# Access Compliance Report

## Public Rights-of-Way

### (Curb Ramps)

Intersection ID: 50584	Main Street: GREAT_LAUREL_RD	Cross Street: GRAND_FIR_RD	Location: NW
ADA ID: 3D6122E7888D	Ramp Type: Perp	Initial Pass/Fail: Fail	Overall Compliance: No
Severity Score: 10			
Codes/Mitigation Info/Possible Solution		Field Measurements/Component Compliance

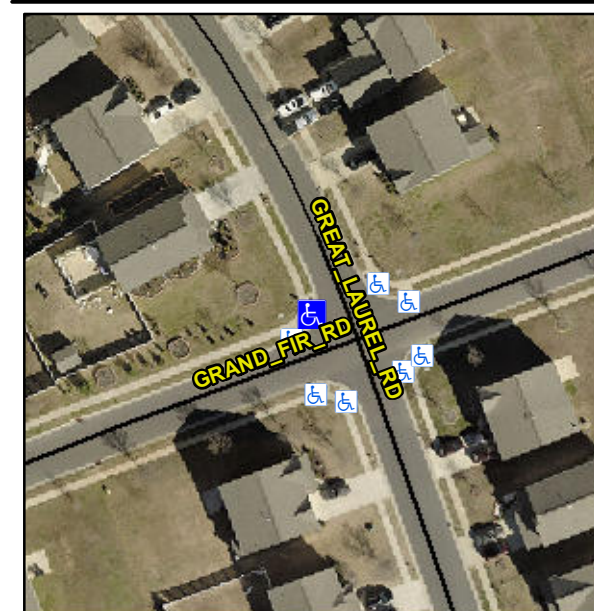
**Not Found, R304.5.1, R304.5.3**

Compliance	Description	Data	Compliance	Description	Data
N/A	Ramp Length (in)	50.5	Yes	Ramp Slope (%)	6.4
No	Ramp Width (in)	47.5	No	Ramp XSlope (%)	3.7
N/A	Flare Type LT	N/A	N/A	Flare Type RT	N/A
N/A	Flare Slope LT (%)	N/A	N/A	Flare Slope RT (%)	N/A
N/A	Flare Traversable LT?	N/A	N/A	Flare Traversable RT?	N/A
N/A	Landing Length (in)	N/A	N/A	DWS Provided?	N/A
N/A	Landing Width (in)	N/A	N/A	DWS Contrast?	N/A
N/A	Landing Slope (%)	N/A	N/A	DWS Length (in)	N/A
N/A	Landing X Slope (%)	N/A	N/A	DWS Full Width?	N/A
N/A	Landing Curb? (Y/N)	N/A	N/A	DWS Offset (in)	N/A
N/A	Shared Landing?	N/A			
N/A	Gutter Ponding?	N/A	N/A	Gutter Slope (%)	N/A
N/A	Gutter Lip Ht (in)	N/A	N/A	Gutter X Slope (%)	N/A
N/A	Painted X Walk1?	No	N/A	Painted X Walk2?	N/A
	X Walk 1 Direction	To E		X Walk 2 Direction	N/A
N/A	X Walk 1 Width (in)	N/A	N/A	X Walk 2 Width (in)	N/A
	X Walk 1 Slope (%)	3.7		X Walk 2 Slope (%)	N/A
	X Walk 1 X Slope (%)	3.9		X Walk 2 X Slope (%)	N/A

**Remove & Replace Entire Ramp.**
